State of Illinois
CAPITAL DEVELOPMENT BOARD

SUBJECT: AMENDMENT NO. 7 TO THE RFP FOR

CDB Project No. 830-010-332
Construction of an Integrated Bioresearch Laboratory (IBRL)
University of Illinois at Urbana-Champaign, Urbana, Champaign County, Illinois

1 SECOND FLOOR SCHEMATIC OVERALL PLAN
A2.0 SCALE: 1/8" = 1'-0"

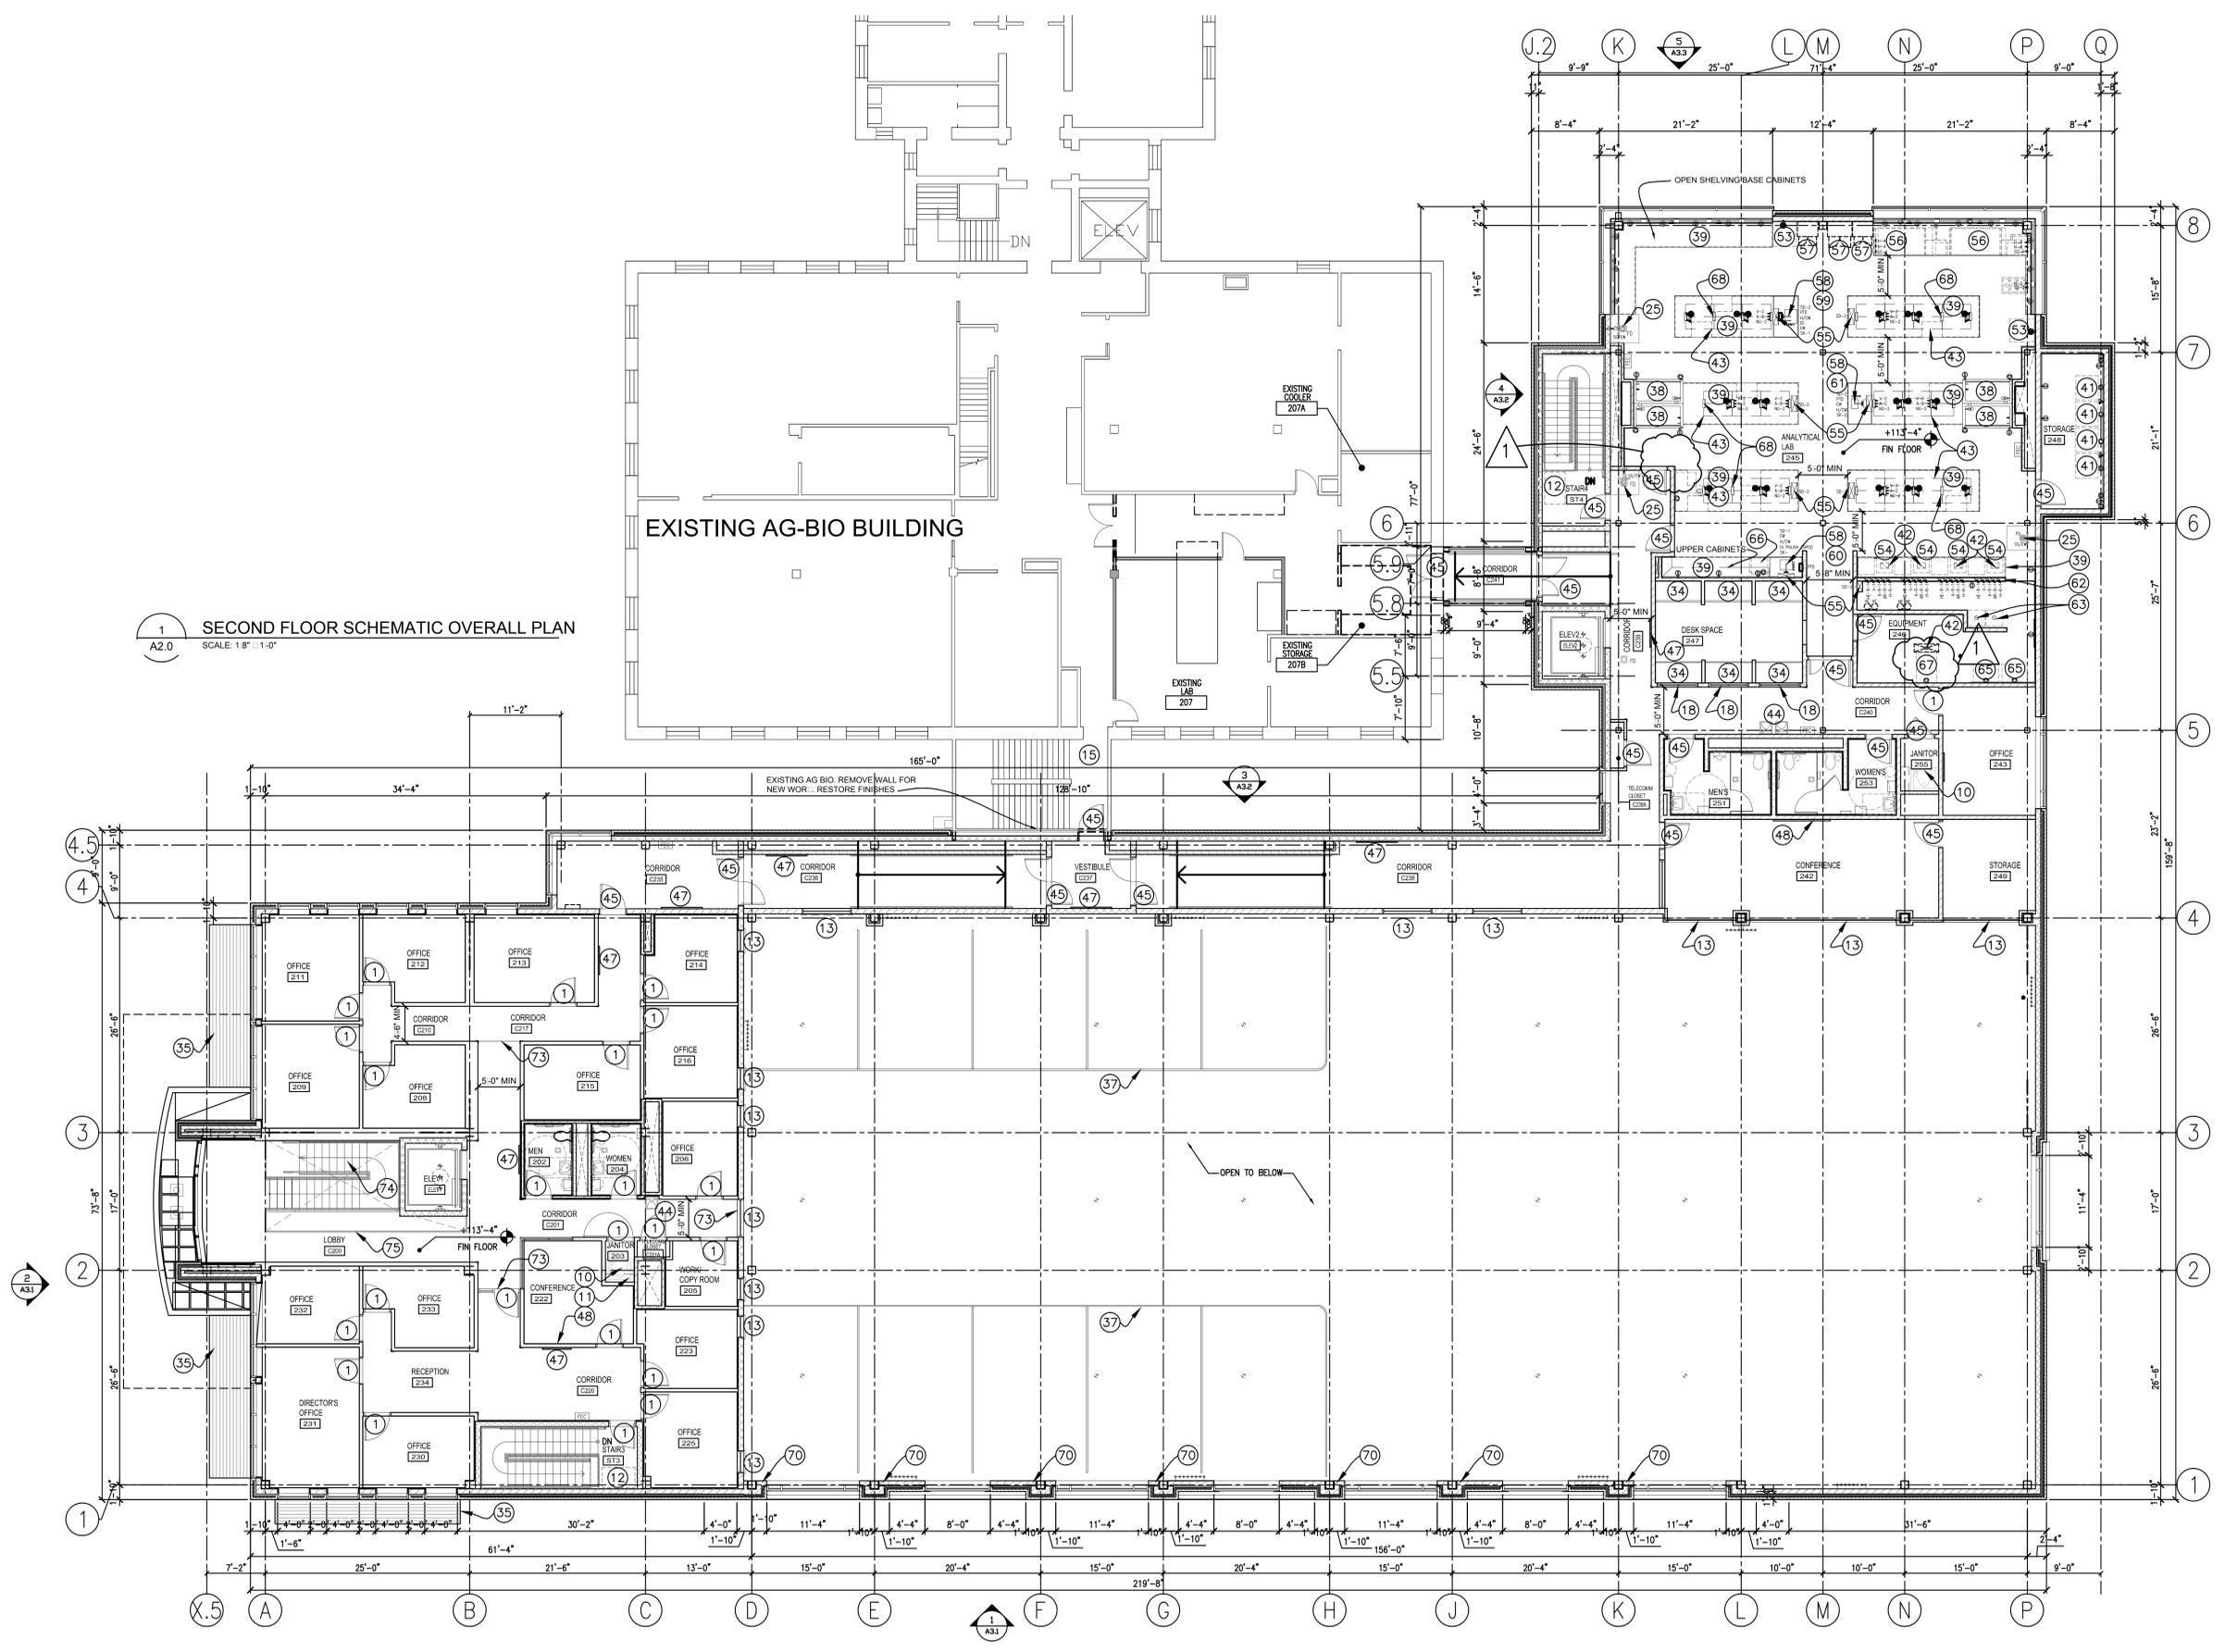
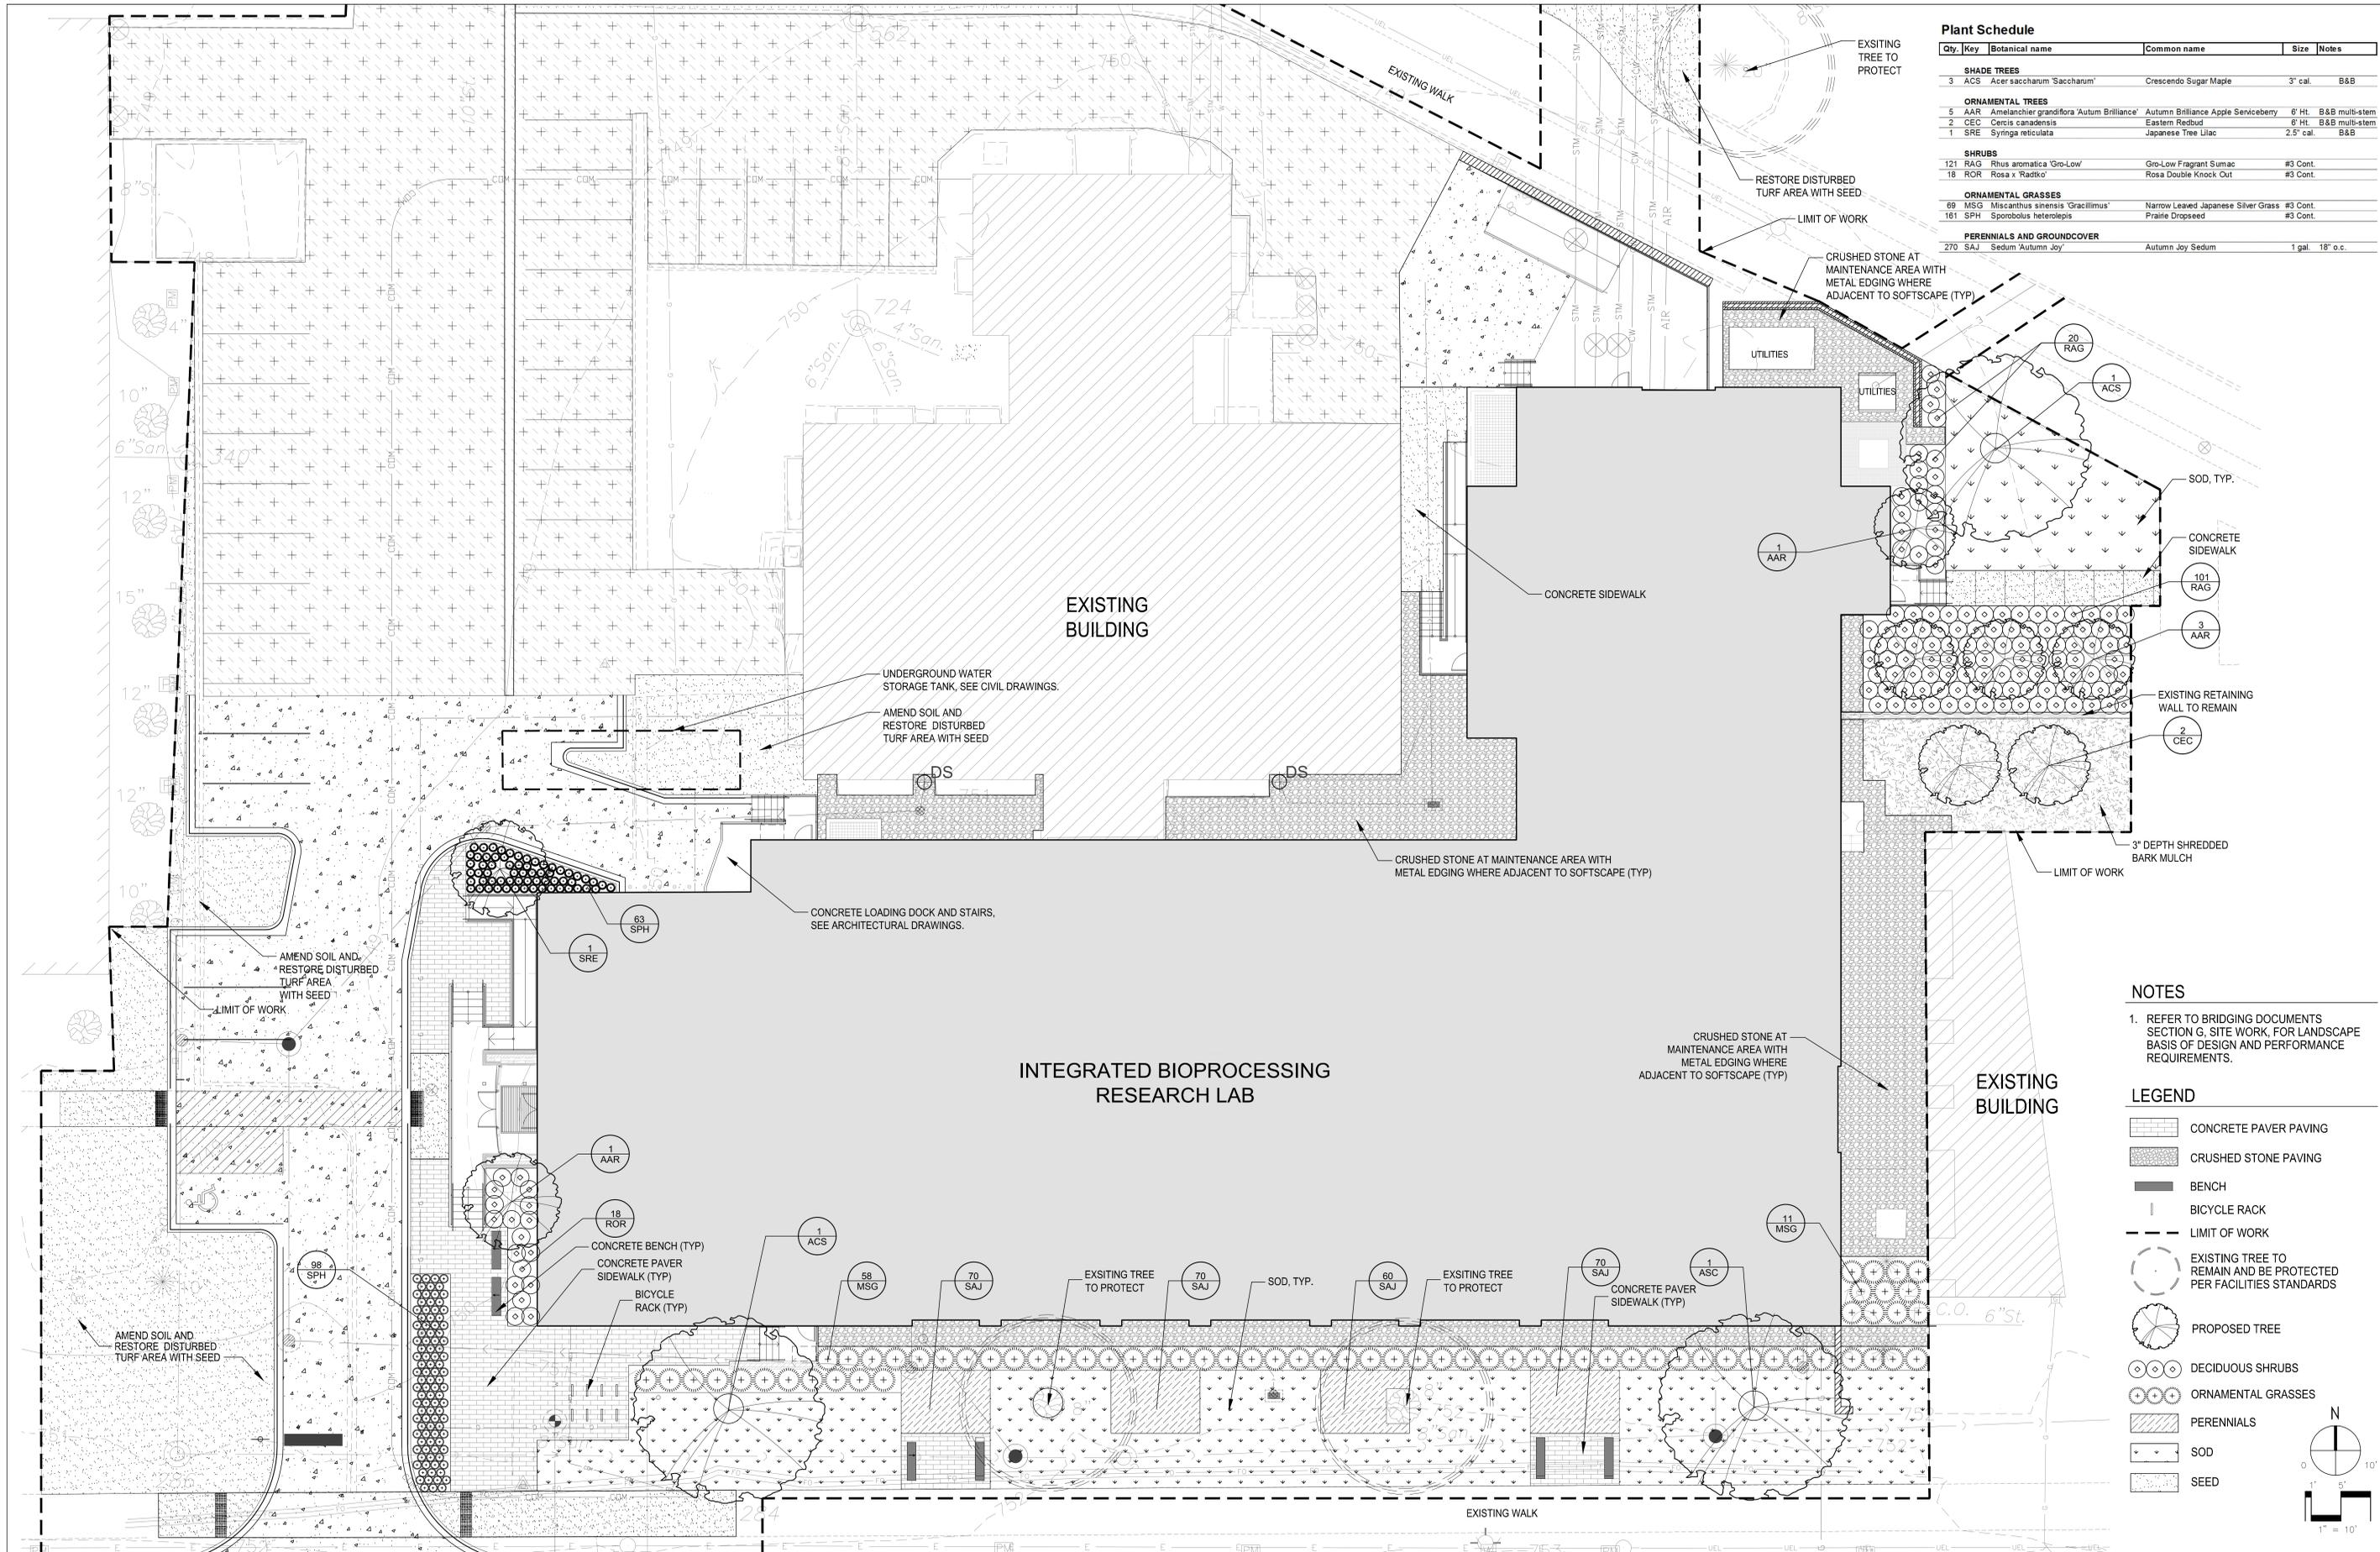
3. Please find attached drawing sheet L1.0, dated 7/05/13.
4. Please find attached drawing sheet A2.0. dated 07/15/13 with modifications to notes and plans. All modifications are “bubbled” and dated 10/21/13.
5. Please find attached drawing sheet S1.0, dated 07/05/13 with modifications to several notes. All modifications are “bubbled” and dated 10/21/13.
